VIRM: IN-SERVICE CERTIFICATION AMENDMENT 1 JUNE 2019

List of changes and preview pages (WoF and CoF)

In this amendment

Figure 5-1-4. Windscreen critical vision area (CVA)

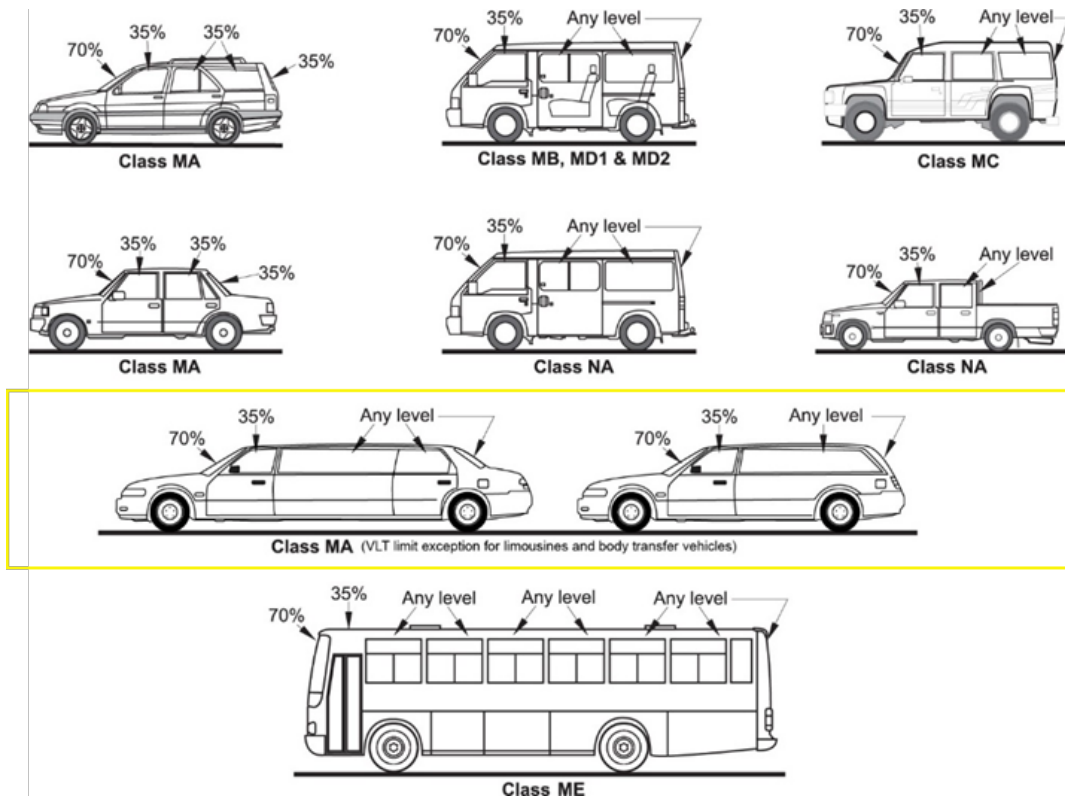
SECTION	CHANGE DESCRIPTION
General vehicles	
4-1 Headlamps	<ul style="list-style-type: none"> • Rfr 15(h) updated to allow for vehicles without a headlamp warning device to be passed if one is not fitted (fitted but not working is still a fail item)
5-1 Glazing	<ul style="list-style-type: none"> • Limousine and body recovery vehicles (hearse) added to figure 5-1-6 Minimum VLT limits for modified glazing (tinted overlays) for different vehicle classes • Critical vision area diagram updated to align with AS/NZS 2080-2006 • Late addition: Table 5-1-6. Permitted modifications <ul style="list-style-type: none"> ○ New row - 'Window port or hatches' in 'Front side window' section relating to class ME vehicles
Heavy vehicles	
4-1 Headlamps	<ul style="list-style-type: none"> • See general vehicles
5-1 Glazing	<ul style="list-style-type: none"> • Critical vision area diagram added
7-1 Seats and seat anchorages	<ul style="list-style-type: none"> • Note added about modification or repair before April 2002

To be measured from the inside of the vehicle from the point where the glass is visible (ie after any seals)

Figure 5-1-8. Windscreen critical vision area (CVA)

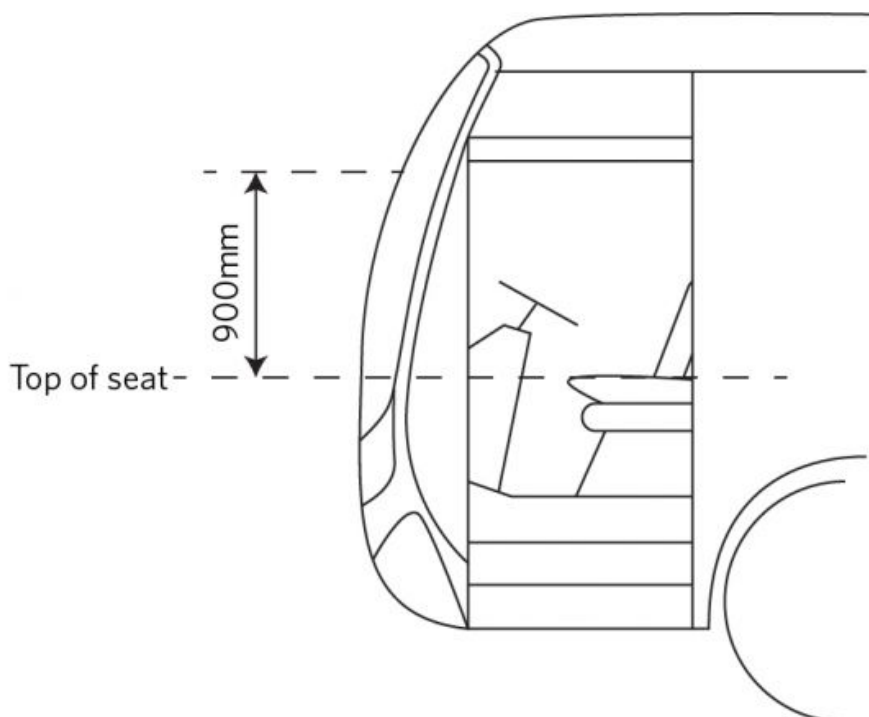
Figure above also added.

Note: Applies to all heavy vehicles, not only buses.

Figure 3-1-3. Drawbar attachment to trailer

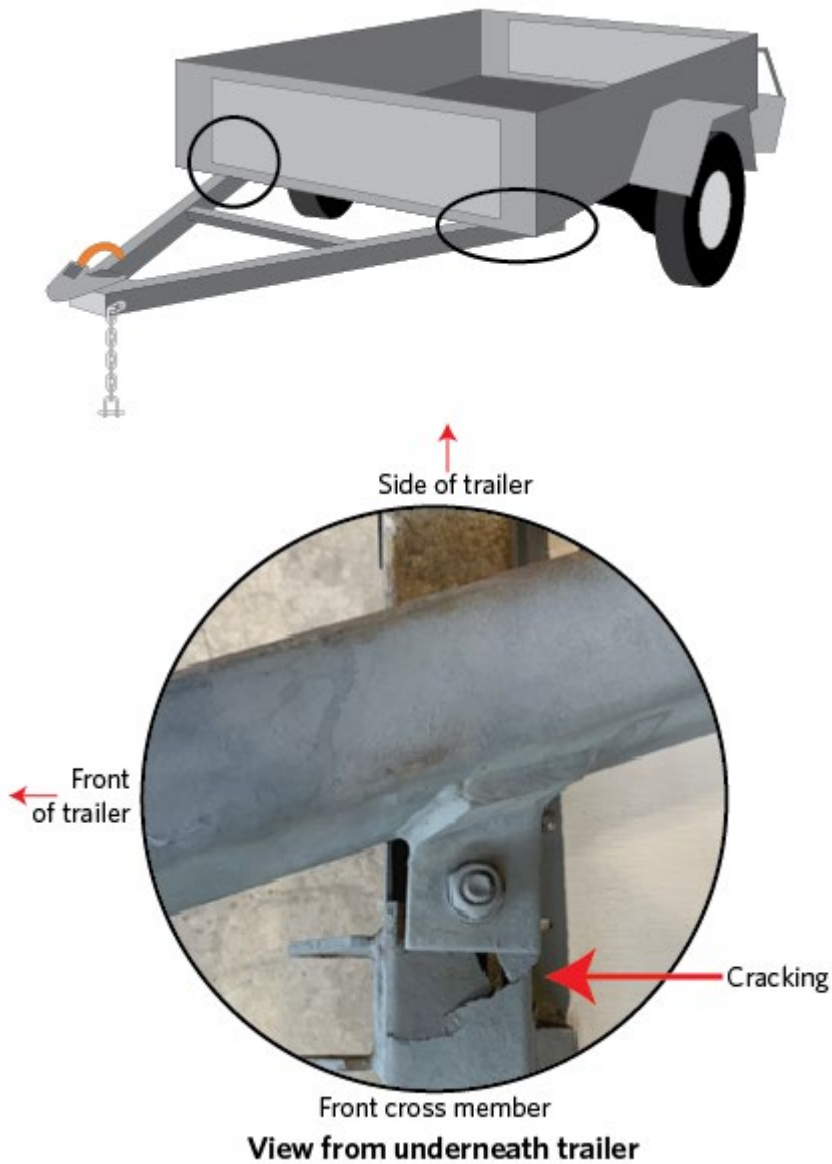
3-1 Structure	<ul style="list-style-type: none"> Note and image added to assist vehicle inspectors with spotting cracking failure at the point(s) where the drawbar attaches to the body of the trailer in light trailers Repaired Trailpro trailers can be identified by the 'R' after the serial number on the plate Image of a repaired Trailpro trailer
---------------	--

Special attention should be given to the point or points where the drawbar attaches to the body of the trailer. This is often the first point of structural failure on trailers.
